# Technical Service Bulletin

<b>Subject:</b>  <b>RATTLE NOISE FROM ENGINE COMPARTMENT AND OIL LEAKAGE FROM DRIVE BELT AUTO TENSIONER</b>	<b>Bulletin No.: 01-008/26</b>
	<b>Last Issued : 04/30/2026</b>

<b>GOOD</b>	<b>GOOD</b>
<b>(TENSIONER - REAR VIEW)</b>	<b>(TENSIONER - FRONT VIEW)</b>

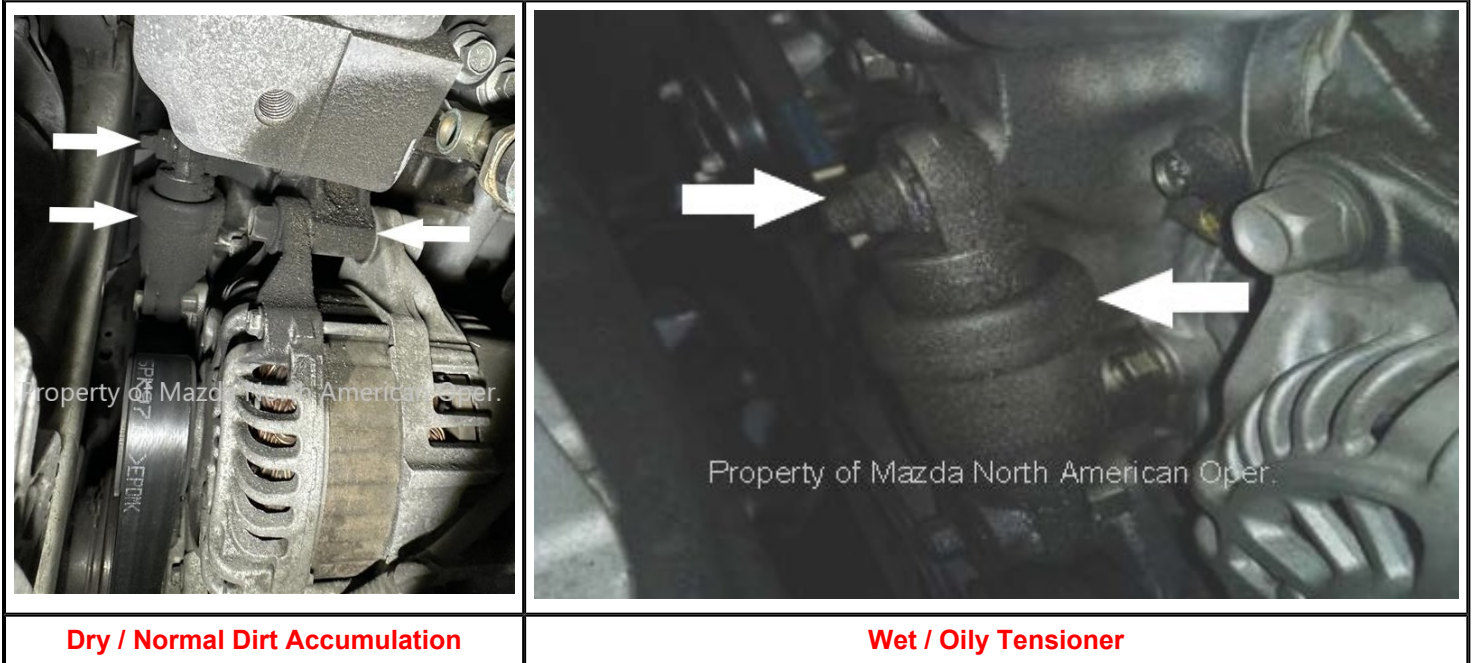
3. Refer to the images below to visually inspect the drive belt auto tensioner condition.

Dry / Normal Dirt Accumulation

Dry / Normal Dirt Accumulation
